**Date:** January 28, 2021
**To:** FC-FS-6 Project Ad-hoc
**RE**: ESP End-to-end Protection CRC Proposal (T11-2021-00022-v000)
**Proposer Contacts:** David Kwak <dkwak@marvell.com>, Ali Khwaja <akhwaja@marvell.com>, Craig W. Carlson <cwcarlson@marvell.com>

This proposal contains detailed text for the ideas contained in T11-2020-223 and T11-2021-00021.

Below are the proposed changes for the ESP End-to-end Protection CRC proposal. New text added for the proposal is indicated in blue.

**Figure 74 - Frame structure with End-to-end ESP_Header and ESP_Trailer**

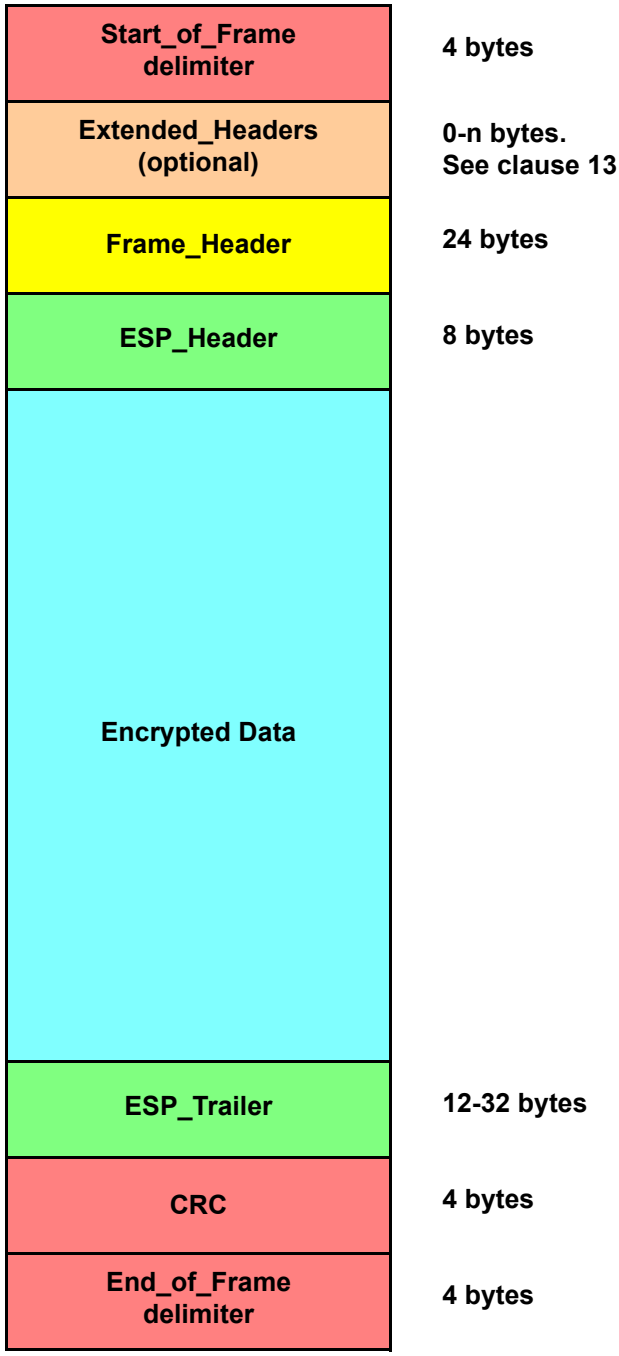
1) Compute the ESP End-to-end Protection CRC if the feature is enabled (see 14.3.5);
2) Add a fixed length ESP_Header (8 bytes) following the Frame_Header, specifying a Security Parameter Index (SPI) and an ESP Sequence Number;

3) Pad the concatenation of any other optional headers, the Payload, and any required fill bytes to the block size required by the negotiated encryption/authentication algorithms. The Pad Length field shall contain the length of this ESP padding, if ESP End-to-end Protection is enabled, place the CRC calculated in 1) into the ESP padding (see 14.3.5);

5) Remove the ESP padding and process the resulting optional headers, Payload, and fill bytes that are present; and
6) Check the ESP End-to-end Protection CRC against the decrypted data if the feature is enabled (see 14.3.5).
